Attachment 1 - PLN19/0011 - 48 - 50 Lithgow Street Abbotsford - Locality Plan

Attachment 2 - PLN19/0011 - 48 - 50 Lithgow Street Abbotsford - Advertising Plans

SLR Consulting Pty Ltd (SLR) has been retained by the City of Yarra to provide a review of the acoustic assessment report for the mixed use development proposed for 48-50 Lithgow Street, Abbotsford.

I refer to the above Planning Application received on 12 March 2019 and the accompanying *Traffic Impact* report (Version 02 dated 12 February 2019) prepared by Impact Consultants in relation to the proposed development at 48-50 Lithgow Street, Abbotsford. Council's Civil Engineering unit provides the following information:

Figure 1: Proposed Ground Floor Plan

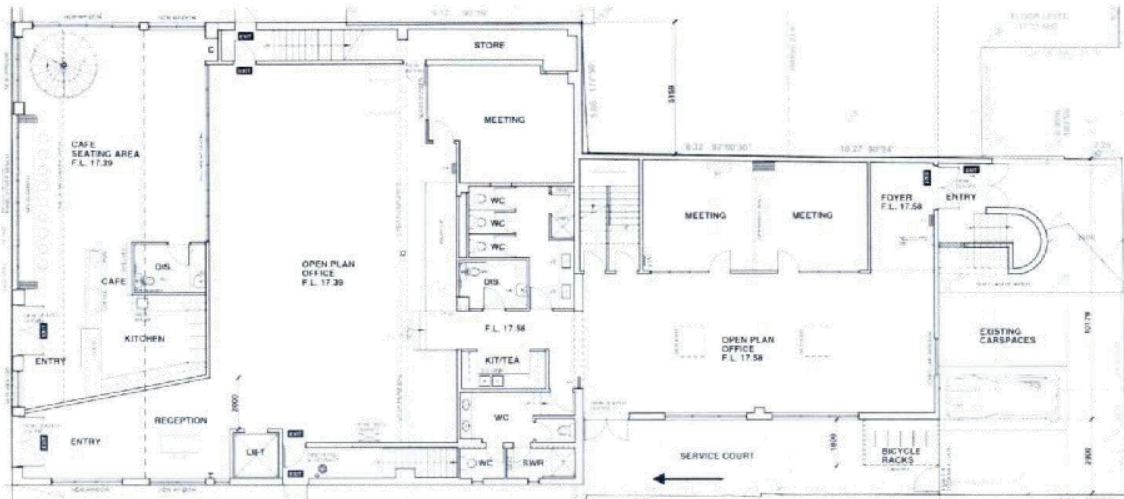
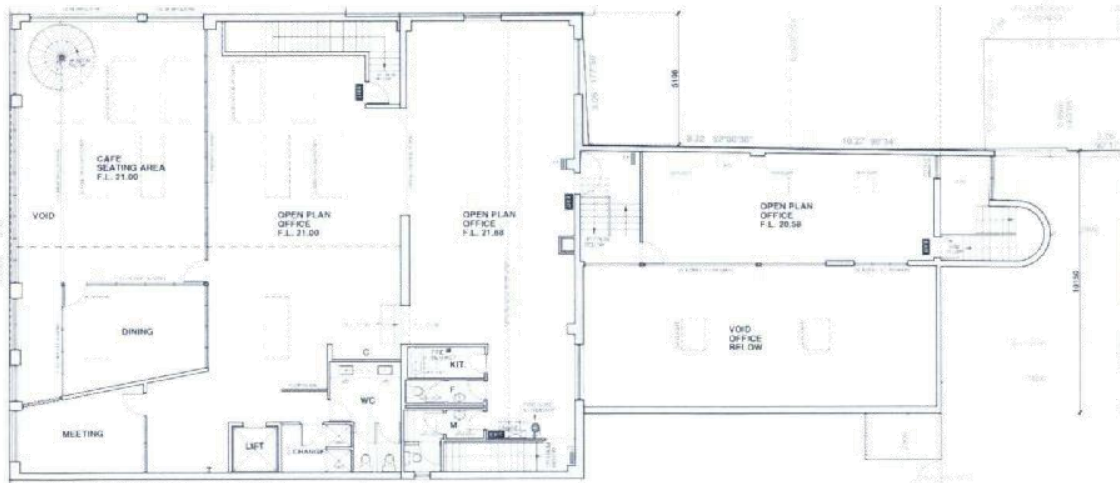
SLR Comments: *The assessment of commercial noise provided in the report is reasonable for the planning stage. We agree that a more detailed review should be undertaken during the detailed design.*
